TECHNICAL RESPONSE TO HCC HIGHWAYS COMMENTS

Ridge and Partners have been commissioned to respond to the Road Safety Audit undertaken by Fenley (March 2026) as part of the S278 Technical Approval Process.

Road Safety Audit Report

Proposed Continuation of Coldharbour Farm Road Emsworth

SUPER LARGE REFUSE VEHICLE - TRACKING
(Scale at A1 1:200)

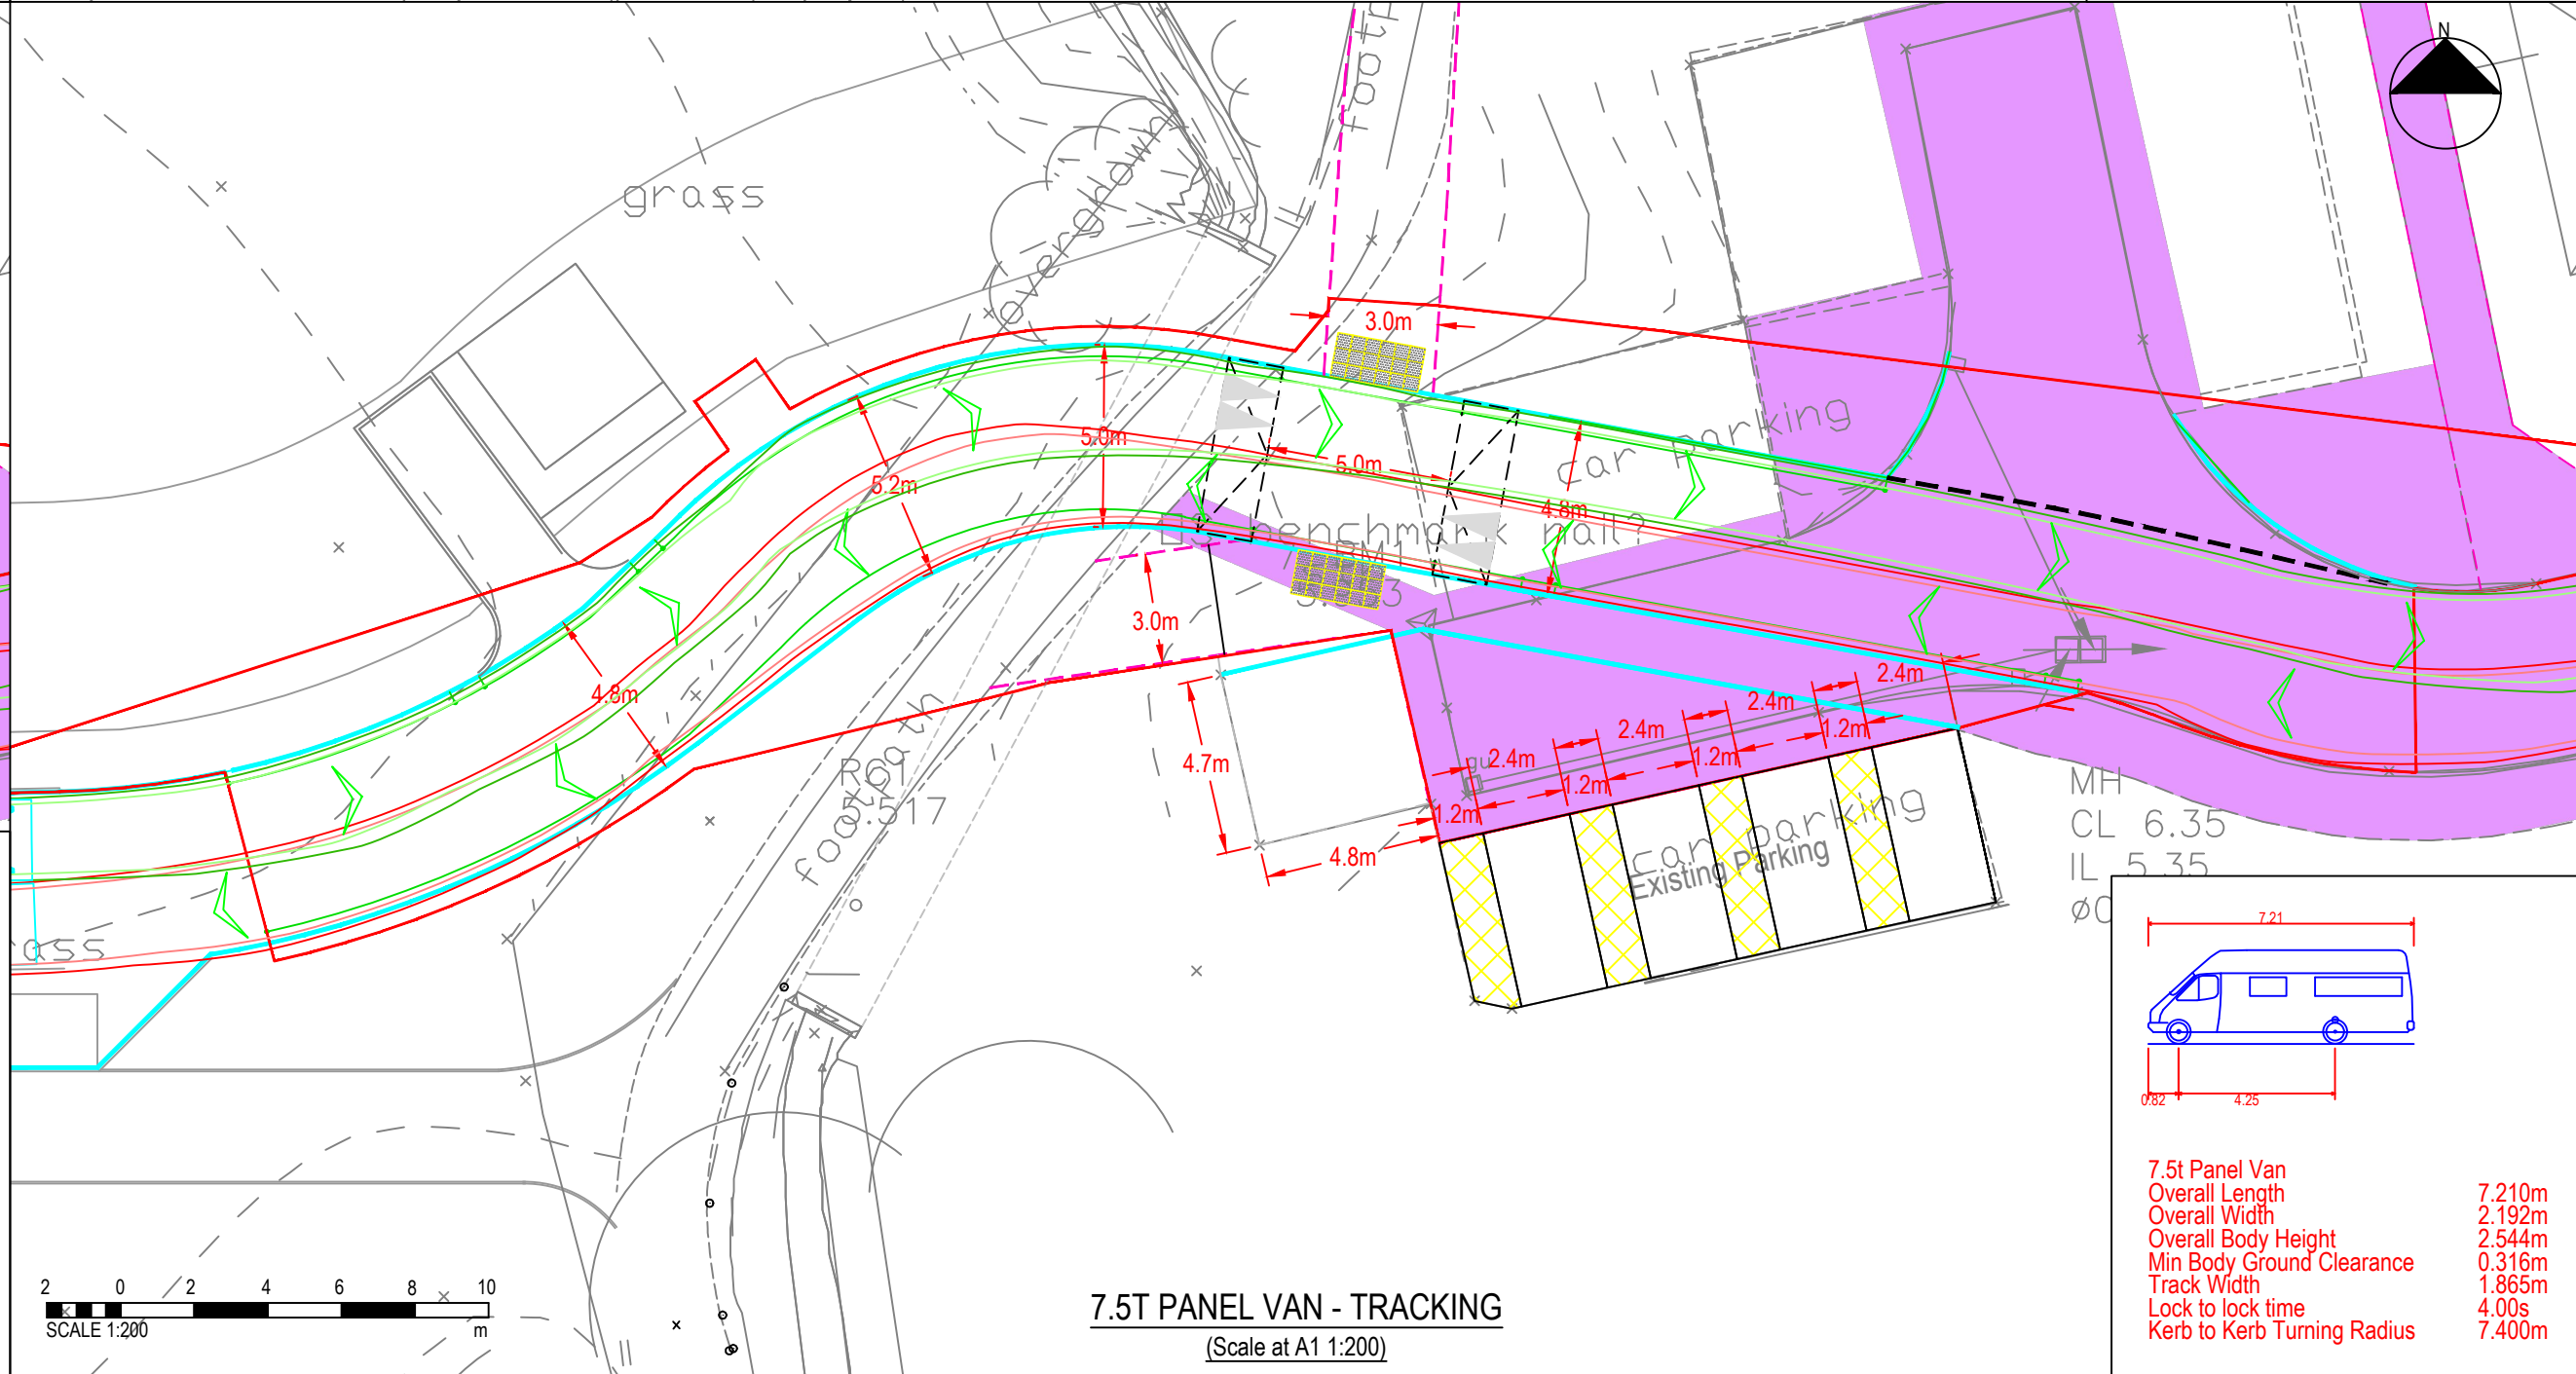
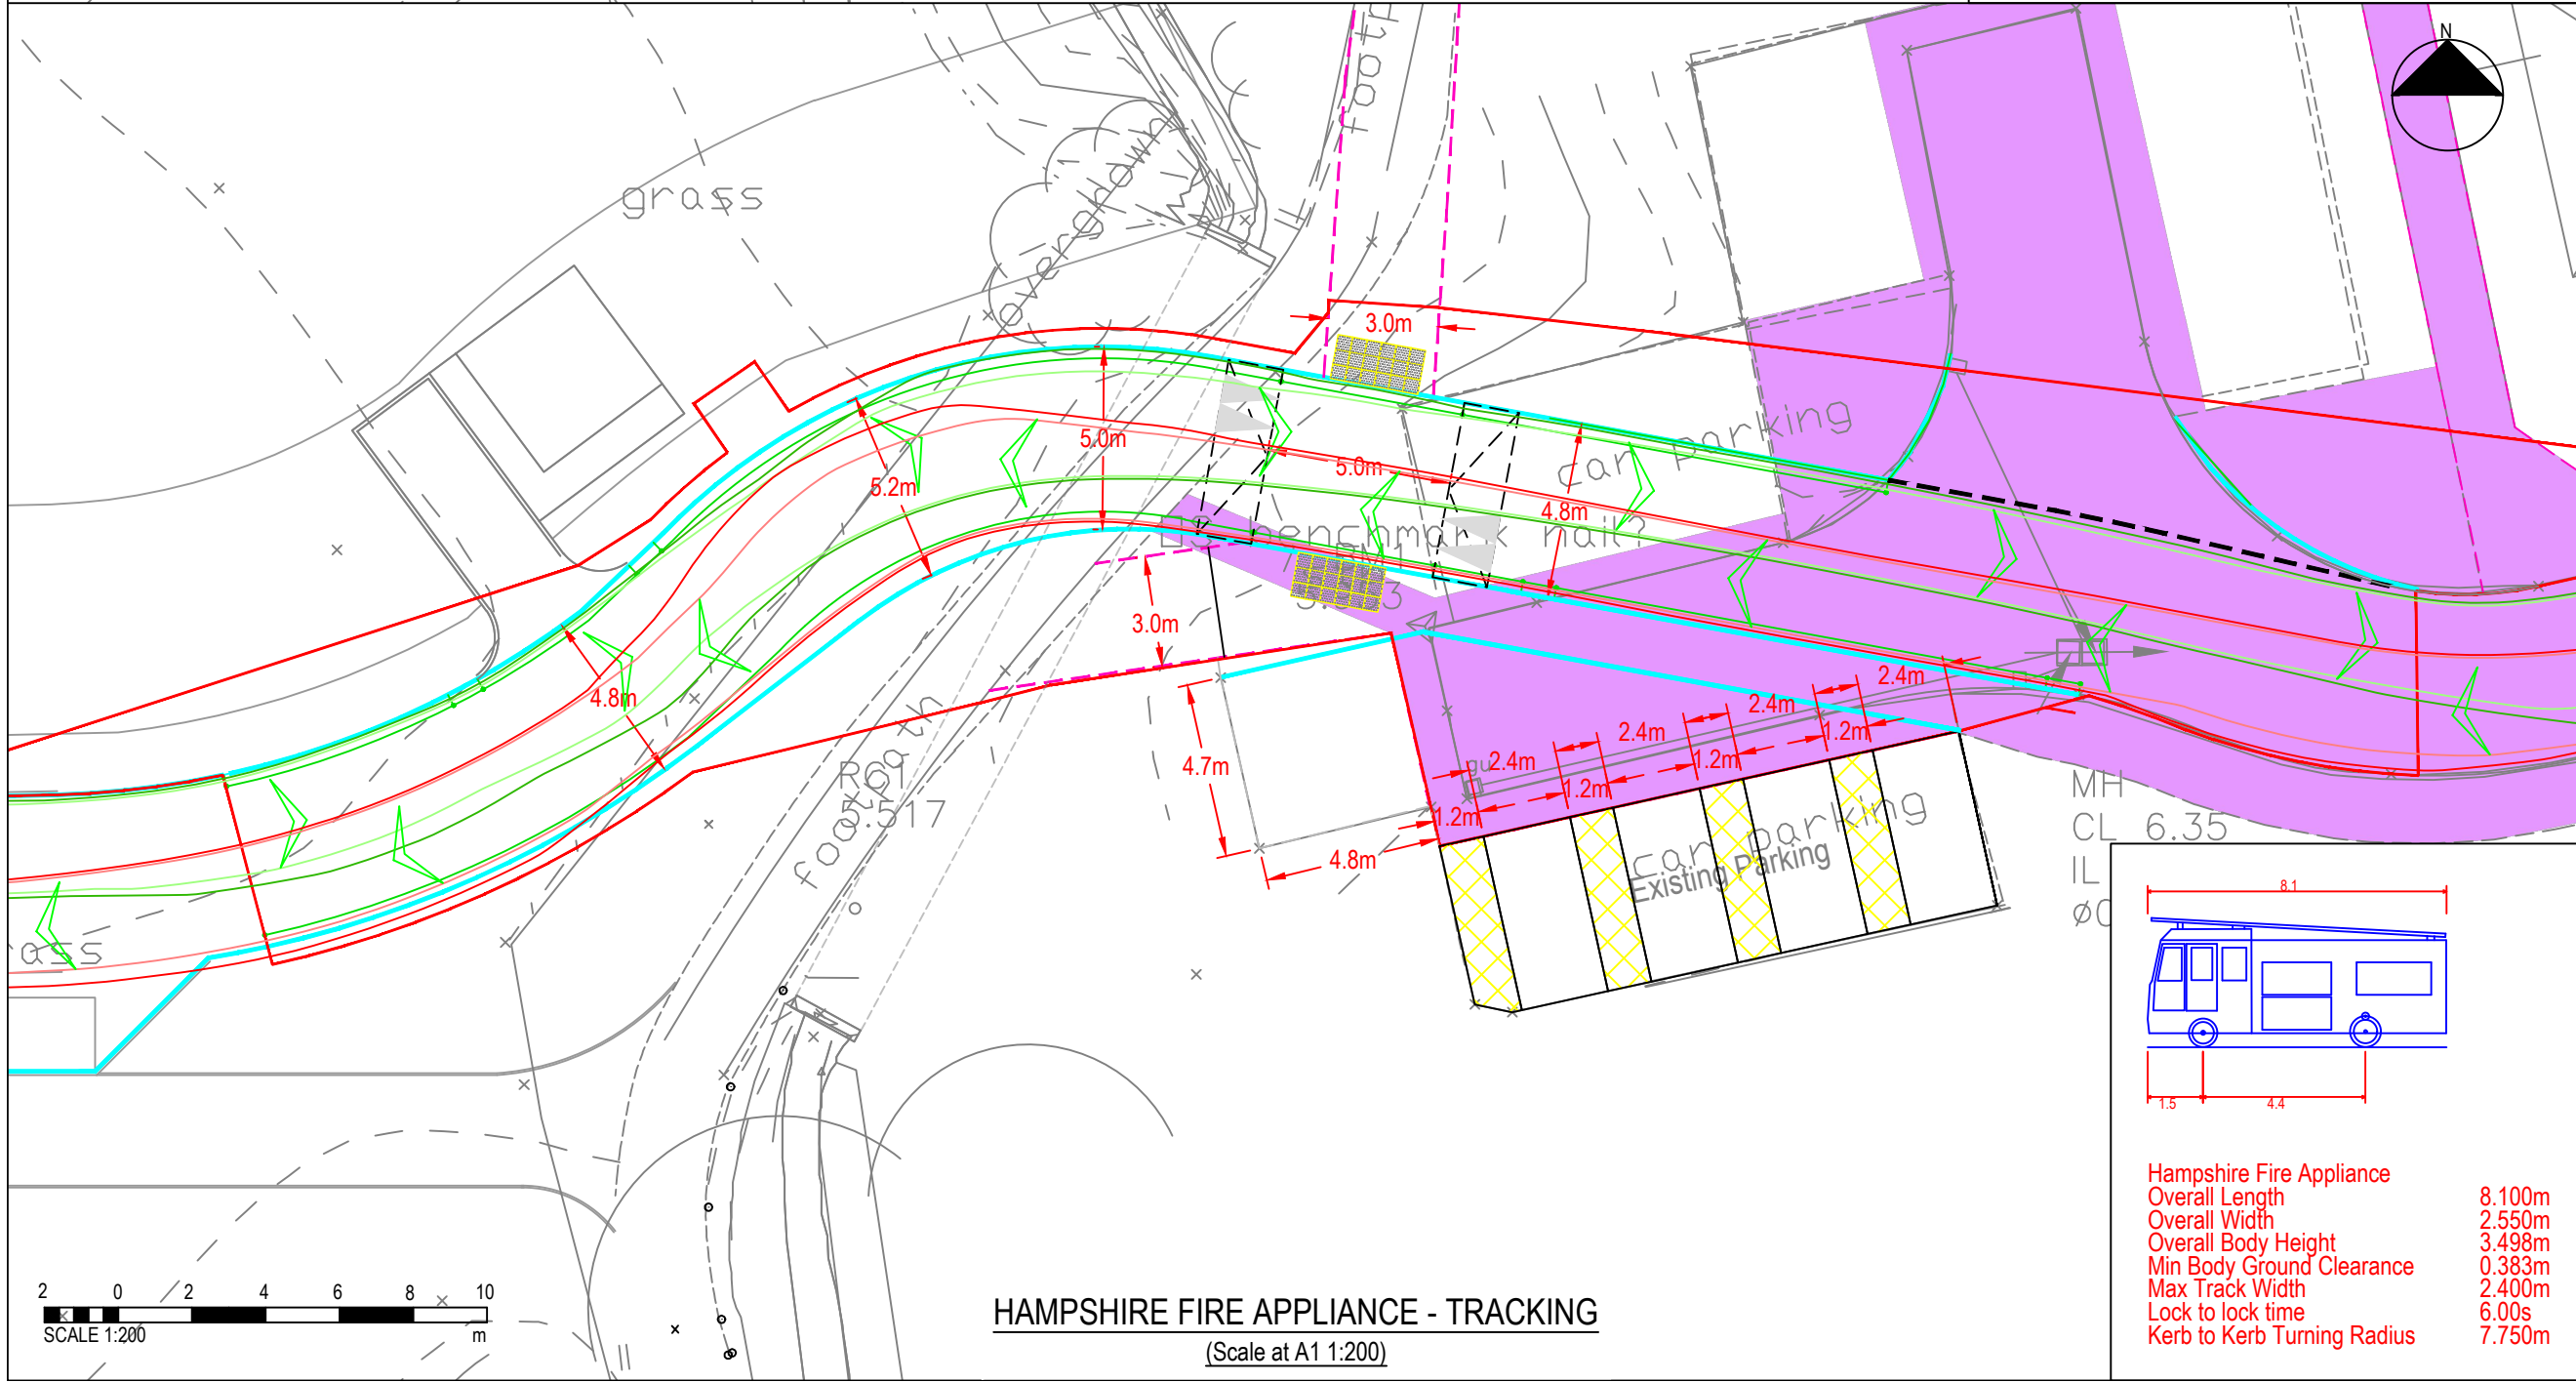
B.1.1 – Alignment may not be adequate for two-way car / LGV movements. It is recommended that the carriageway is adequate for cars and LGVs to pass one another.

We have provided updated tracking Drawing 23339-JUBB-XX-XX-DR-X-001200 REV C4 that shows in the bottom right that cars can pass each other.
